Ref: 33691YJ Site Report 1

## Site Report

### **GEOTECHNICAL PILE INSPECTION PROPOSED RESIDENTIAL DEVELOPMENT 13 MONASH CRESCENT, CLONTARF, NSW**

# Sketch 1: Pile Inspection Plan

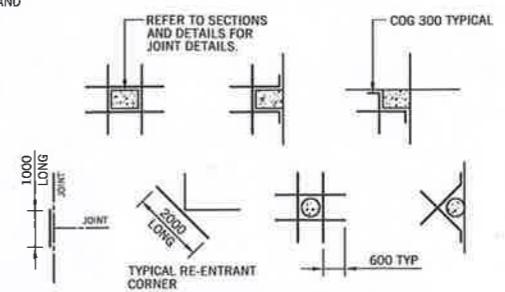
JK Geotechnics witnessed the drilling of five Type P1(U) piles, nominated as Pile Nos. 1 to 5, that were drilled using a 6-tonne CFA piling rig operated by A Class Piling & Drilling Pty Ltd. These piles are shown in the attached Sketch 1, which used the Partridge drawing as a base plan. David Hawkes of Watershed Building Group provided the approximate surface level of where the piles were drilled.

Pile No.	Pile Diameter (m)	Approximate Surface Level (RL mAHD)	Drill Depth from Surface (m)	Approximate Pile Toe Level (RL mAHD)
1	0.45	2.7	3.80	-1.10
2	0.45	2.7	3.86	-1.16
3	0.45	2.7	3.84	-1.14
4	0.45	2.7	3.60	-0.90
5	0.45	2.7	3.63	-0.93

From reference to the boreholes and DCP tests carried out in our previous geotechnical investigation, tactile examination of the materials recovered during drilling and pile depths achieved, it is our opinion that the piles reported in the table above and drilled in our presence are likely founded on materials suitable for the design ABP of 700kPa. This assessment is made on the basis that the proposed seawall will be properly engineered and constructed and will prevent the loss of sand from the site. If this is not the case and there is the potential that sand will be lost from around the piles thus reducing their embedment depth, the above piles will not be suitable for an ABP of 700kPa. On the assumption that a seawall will be installed that will prevent the loss of sand, the remaining piles should be drilled to similar depths and founded on at least medium dense sand.
